PROJECT: Coleman Community Schools – 2026 Renovation Projects

SUBJECT: Addendum No. 1

Addendum No:	#1	Project Number:	21-949
Project:	Coleman Schools Coleman JR/SR High School	Date:	10.26.2026
Issued To:	Wolgast

A0.0

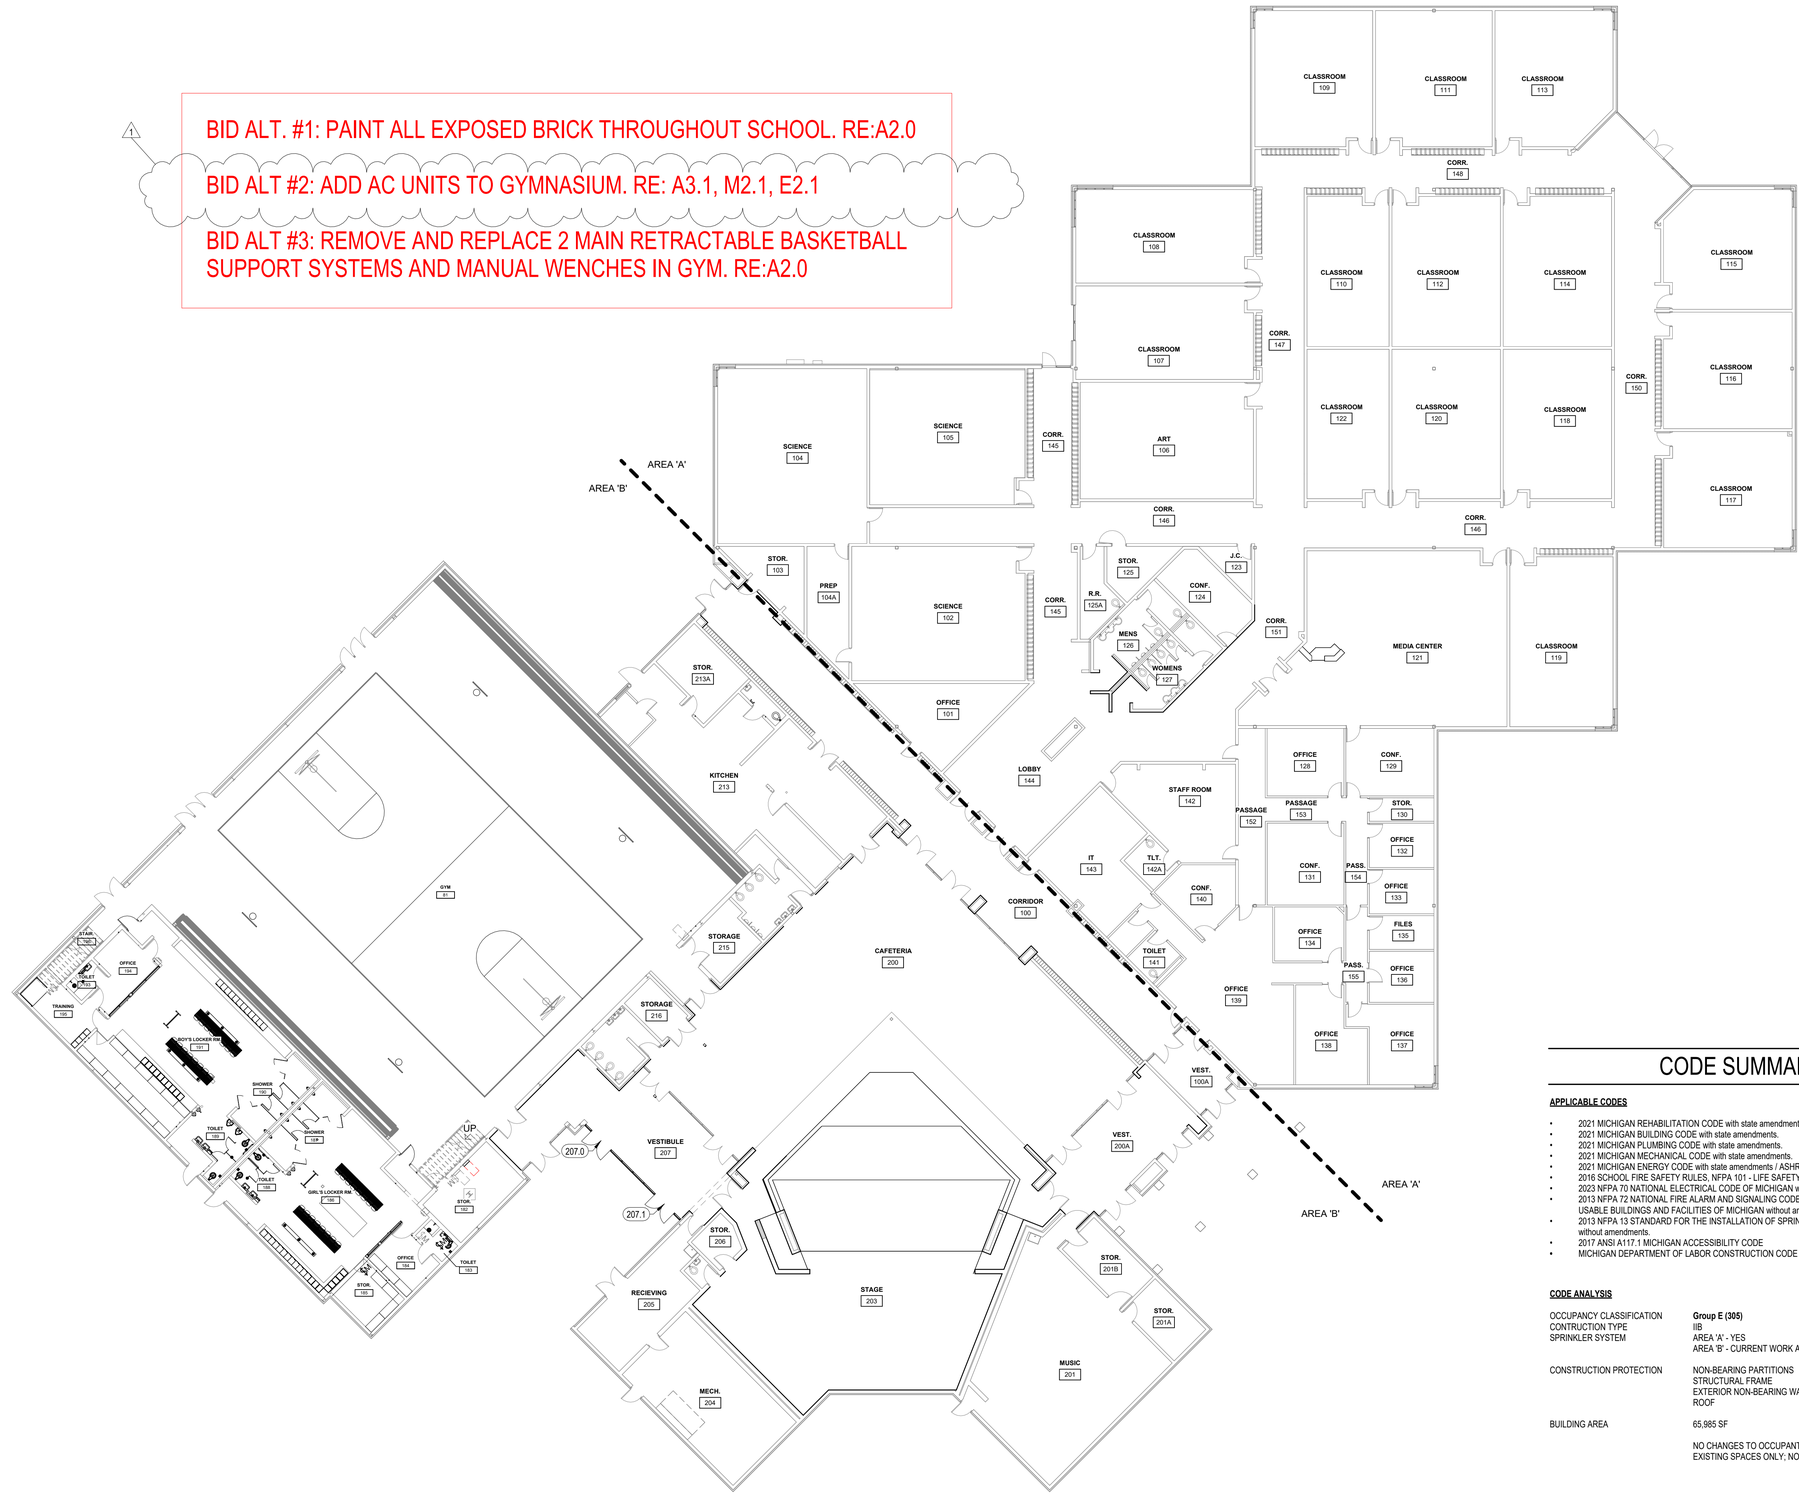
- RFI No. 4
  Question: Bid Alt #2 on Drawing A0.0, should this include architectural drawings as well.
  Answer: Full scope covered in Mechanical and Electrical Drawings apart from Architectural Sheet A3.1 which includes some penetration infill. Please see attached Architect's write-up for clarifications to architectural sheets marking what is part of bid Alt.

Item 7: WALL INFILL DETAILS AND CLARIFICATIONS TO BID ALT #2

New/Revised Sheets: A0.0, A3.1
New/Revised Specifications:

1 BID ALT. #1: PAINT ALL EXPOSED BRICK THROUGHOUT SCHOOL. RE:A2.0

BID ALT #2: ADD AC UNITS TO GYMNASIUM. RE: A3.1, M2.1, E2.1

BID ALT #3: REMOVE AND REPLACE 2 MAIN RETRACTABLE BASKETBALL SUPPORT SYSTEMS AND MANUAL WENCHES IN GYM. RE:A2.0

A1.1

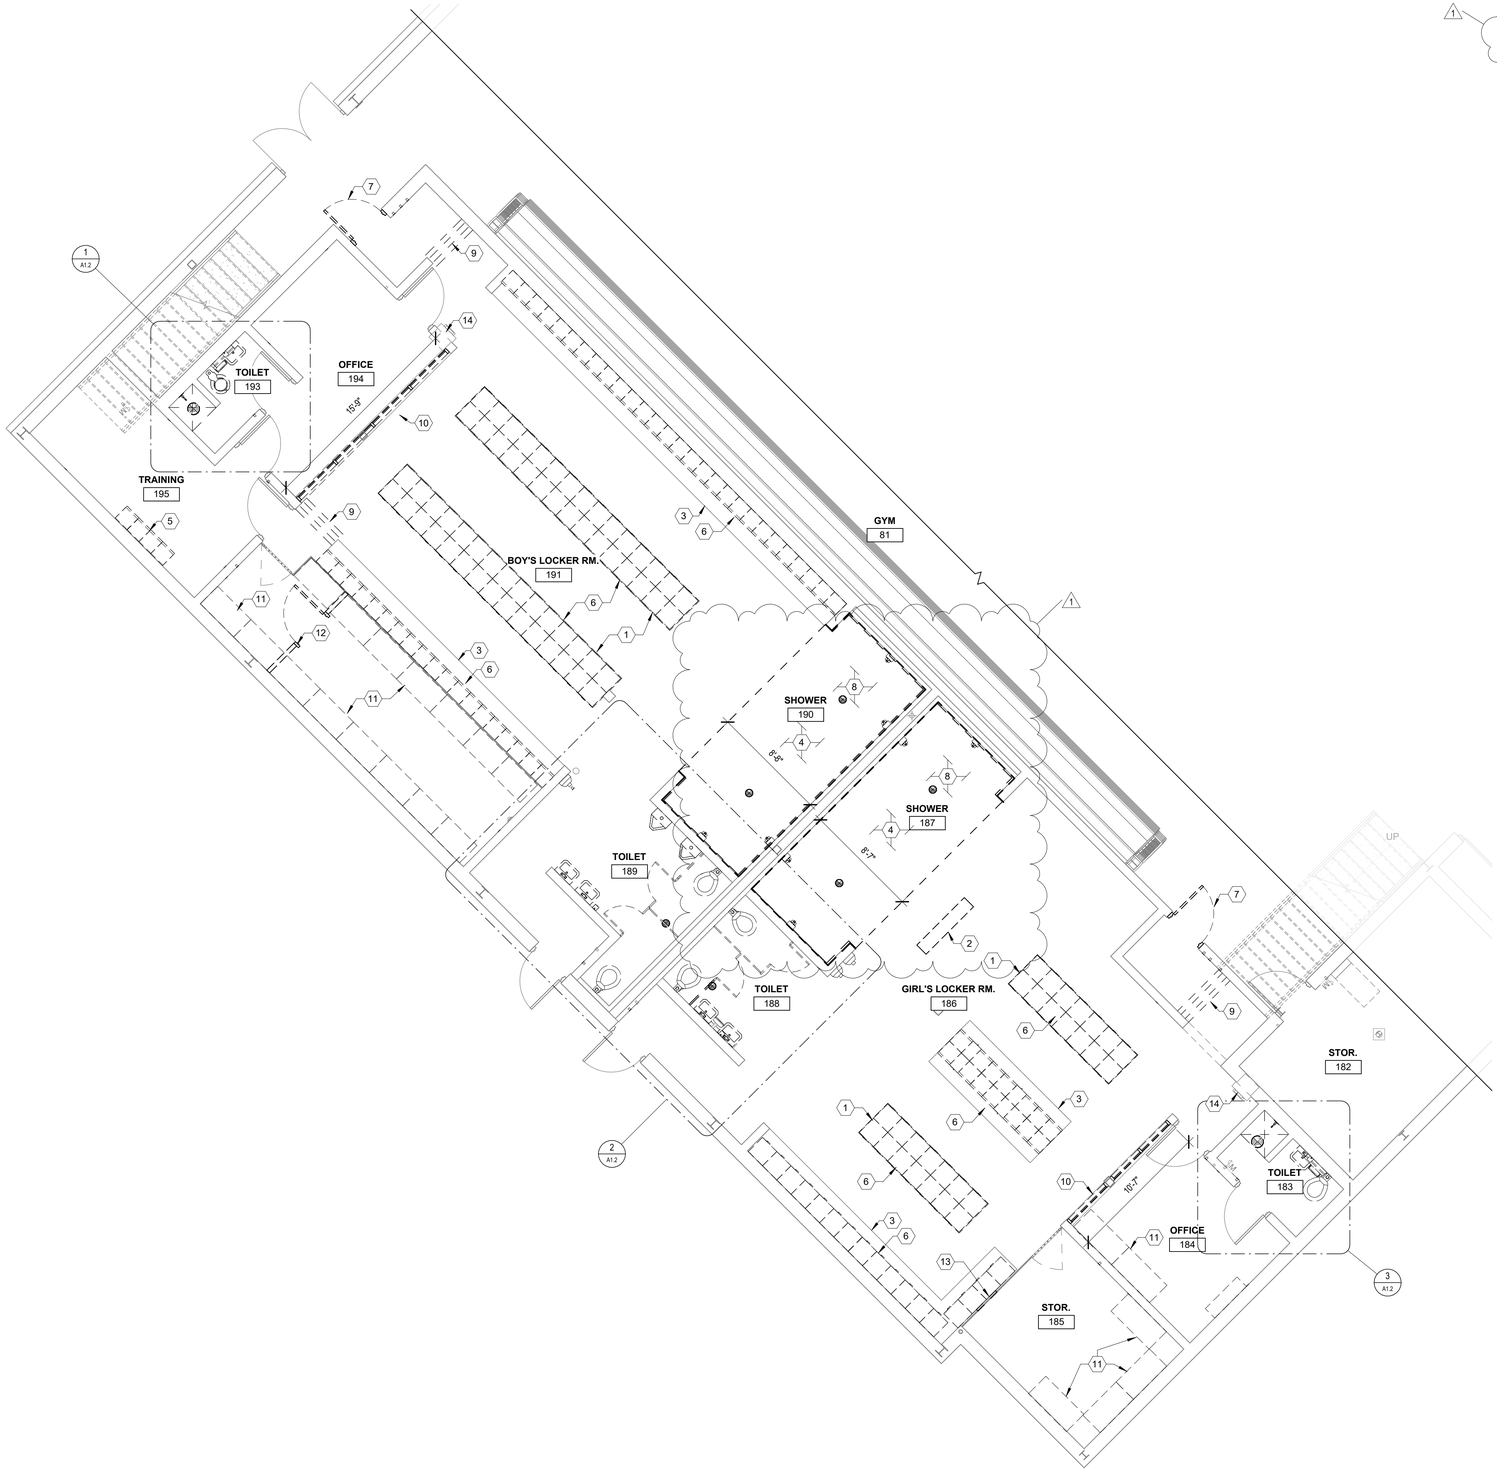
- RFI No. 2
  Question: Item 1 asks for a new 4" concrete floor. However, it is not clear in the demolition plans that it should be completely removed.
  Answer: Keynote #2 calls for dowling, so yes this concrete to be completely removed. Please use all three keynotes.

Item 5: CUT SLAB FOR SHOWERS

New/Revised Sheets: A1.1
New/Revised Specifications:

4. DEMO SLAB IN SHOWER TO EXTENT REQUIRED FOR NEW SLOPED SHOWER AREAS. DEMO TILE FLOOR AND TILE WALL IN SHOWER ROOMS. PREPARE FOR NEW WORK TILE WALL AND EPOXY FLOOR. RE: STRUCTURAL AND PLUMBING DWGS FOR FURTHER SCOPE.

A2.1

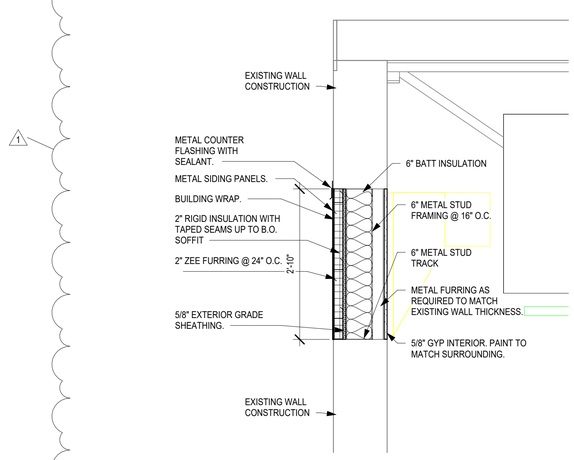
Item 1: NEW LOCKER BENCHES ADDED. ALL WIRE MESH CAGES IN BOYS AND GIRLS LOCKER ROOMS TO BE PAINTED – COLOR TO BE COLEMAN BLUE TO MATCH BLUE COLOR USED THROUGHOUT SCHOOL. 40’ LINEAR FEET TOTAL.

New/Revised Sheets: A2.1
New/Revised Specifications:

20. NEW SHOWER PARTITION. RE: SPECIFICATION.
21. ALL WIRE MESH CAGES IN BOYS AND GIRLS LOCKER ROOMS TO BE PAINTED – COLOR TO BE COLEMAN BLUE TO MATCH BLUE COLOR USED THROUGHOUT SCHOOL. 40 ' LINEAR FEET TOTAL.

A4.0

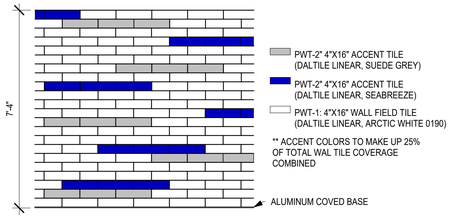
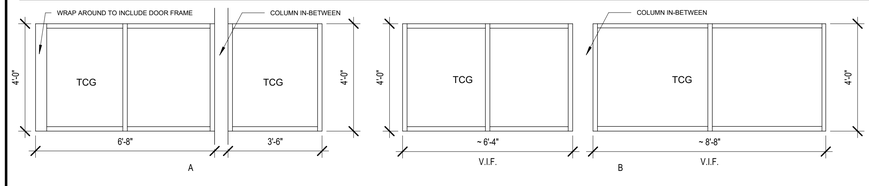
- RFI No. 1
  Question: Door schedule references Details on Drawing A9.0. Architectural drawing sequence ends with Drawing A6.0.
  Answer: Please reference Detail on Drawing A6.0.

Item 4: UPDATED DOOR SCHEDULE WITH DOOR HARDWARE NUMBERS

New/Revised Sheets: A4.0
New/Revised Specifications:

17 SHOWER TILE LAYOUT
3/8" = 1'-0"

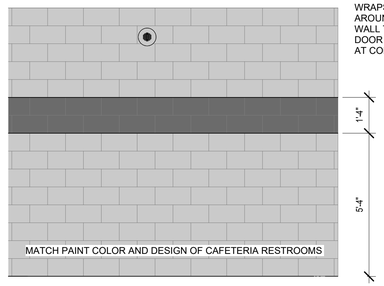
Item 6: SHOWER TILE TYPE AND LAYOUT

New/Revised Sheets: A2.0
New/Revised Specifications:

7 TYPICAL CASEWORK CONSTRUCTION
1" = 1'-0"

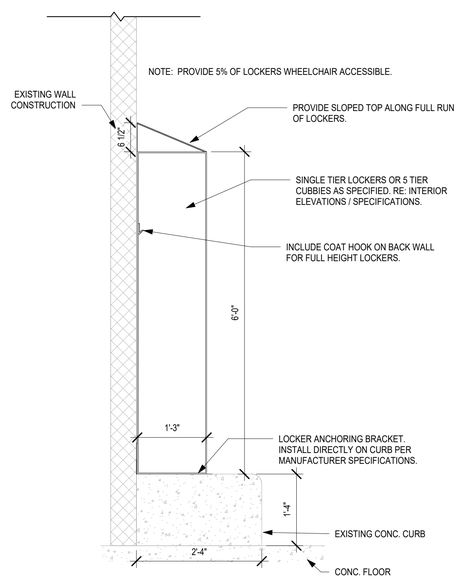
Item 2: TYPICAL CASEWORK DETAIL ADDED

New/Revised Sheets: A6.0
New/Revised Specifications:
